The Road to Licensure and Beyond

The Road to Licensure and Beyond
Sample Graphic Vignette Problems

Evaluating Your Sample Solutions

Sample Problem 1
Solution 1 of 12

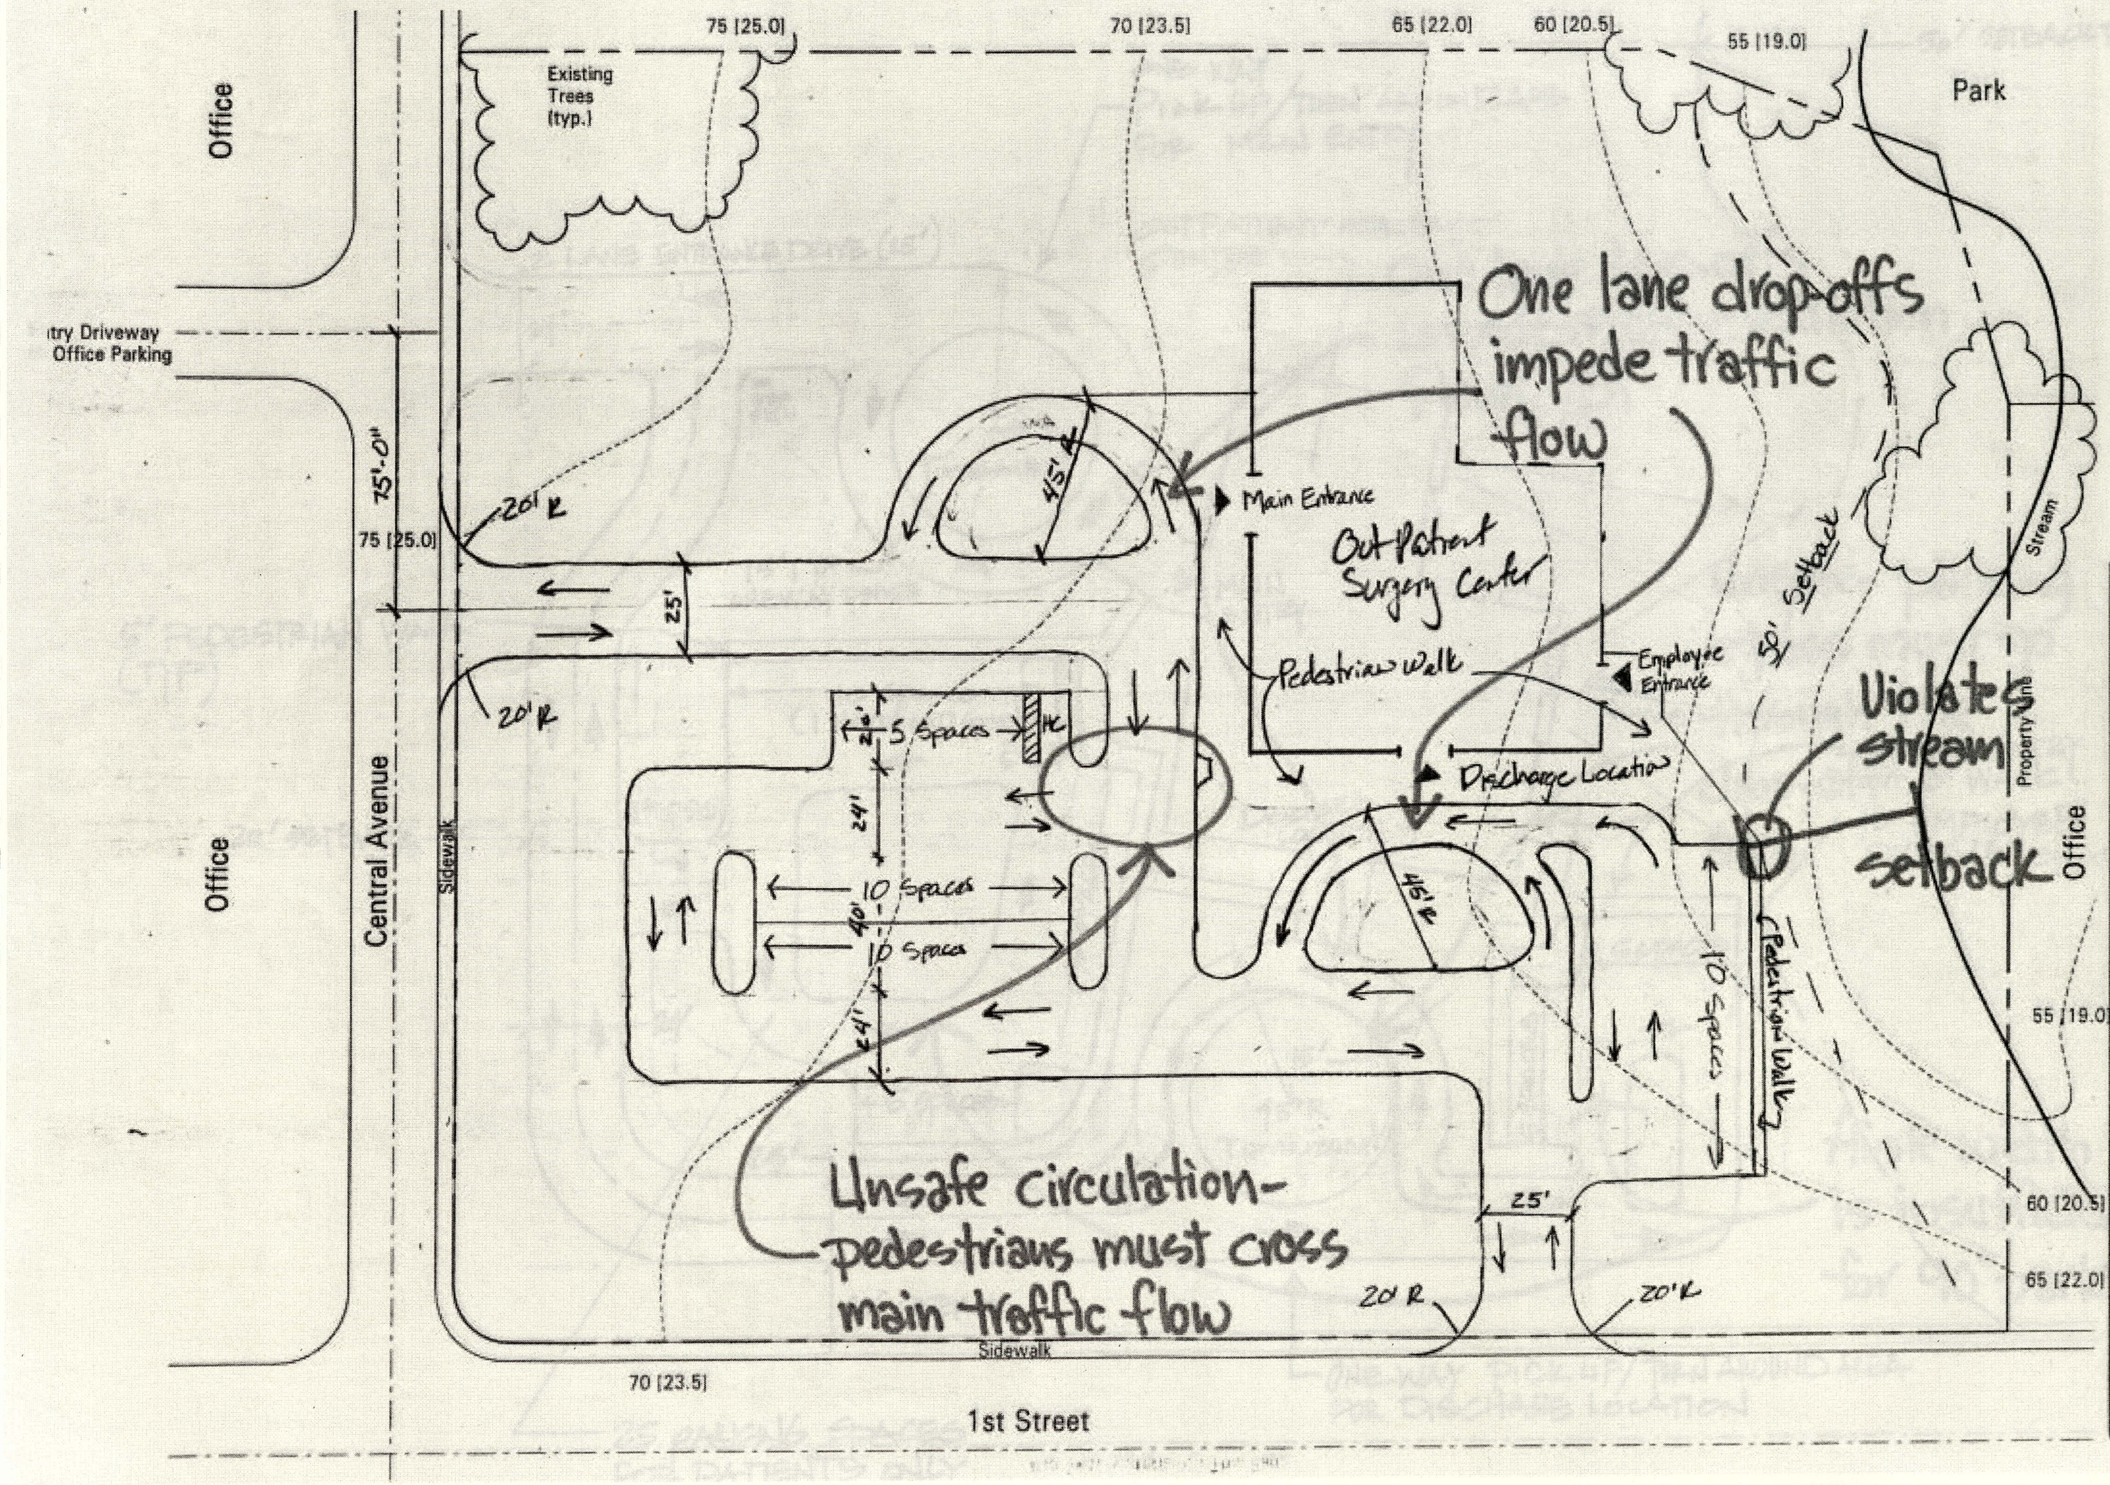
One lane drop-offs impede main circulation flow

Unsafe- parking egress must go through the drop-off area

Aisle width is insufficient for 90° parking

Sample Problem 1
Solution 5 of 12

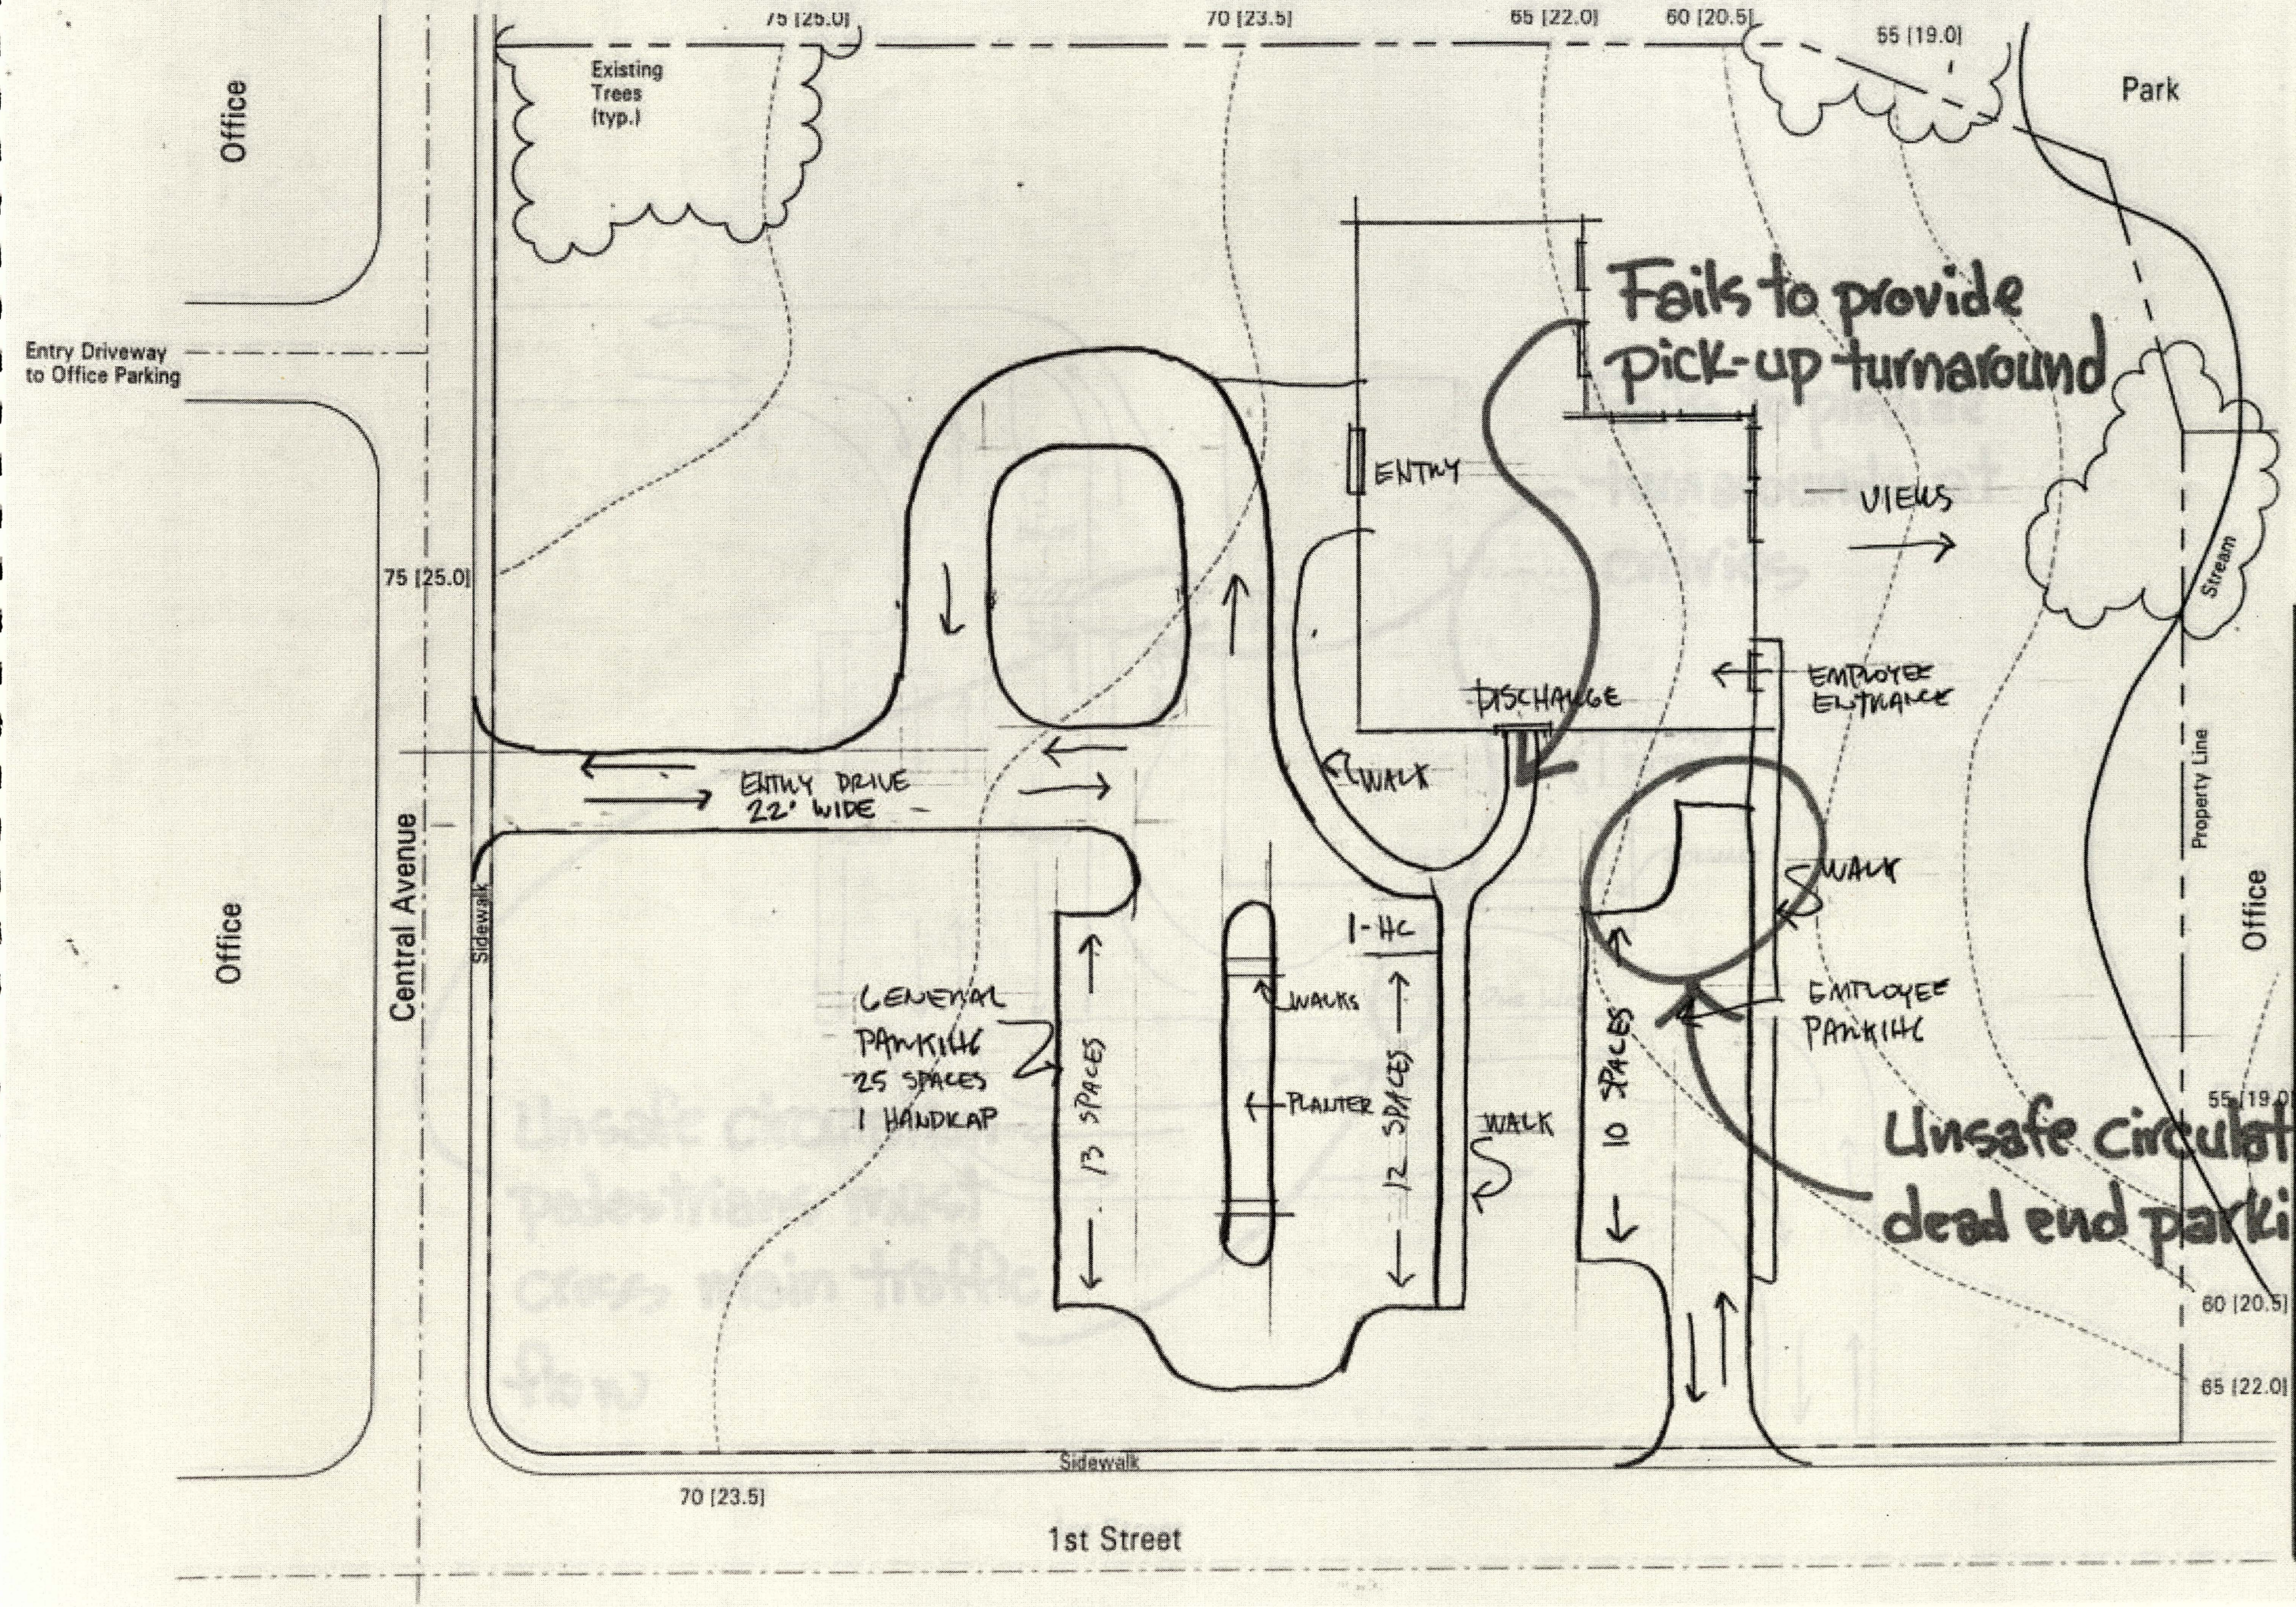
Unsafe circulation - cars back into main traffic flow

omit spaces

Insufficient turning radius

Insufficient aisle width for cars backing out

Sample Problem 1
Solution 9 of 12

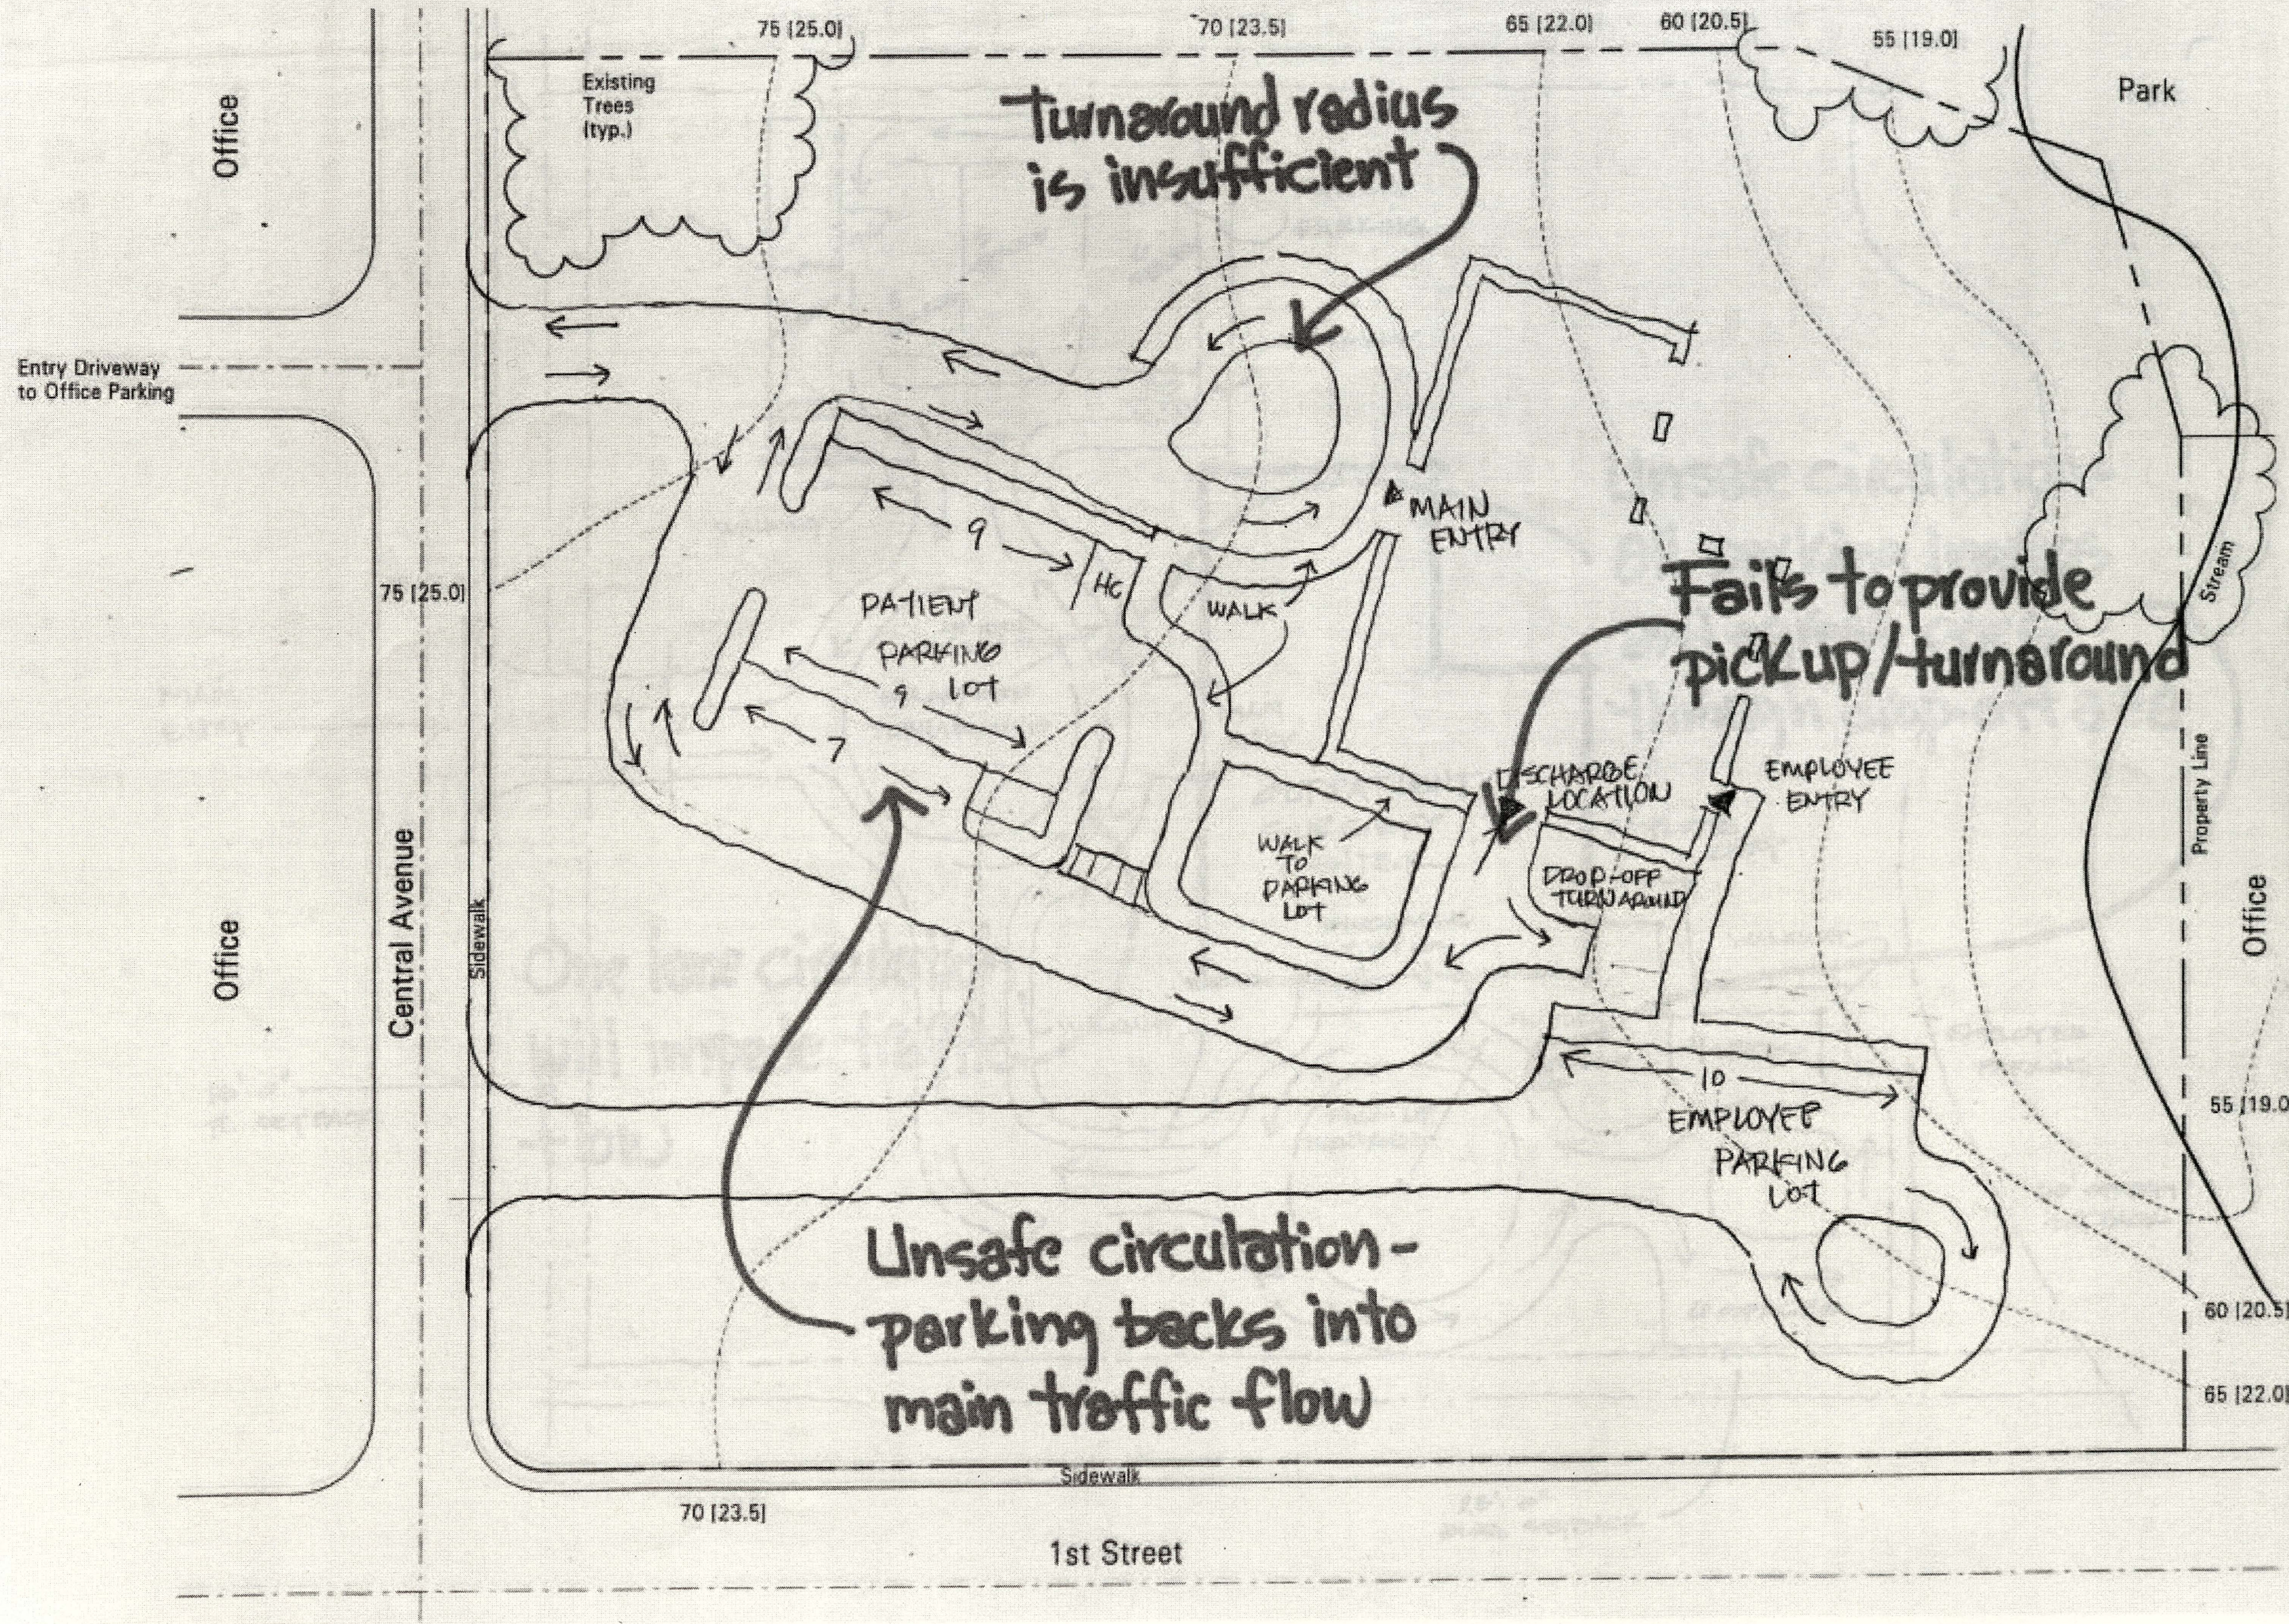
Fails to provide HC space per code

Parking does not serve both entries - vehicles must exit site to access discharge pick-up
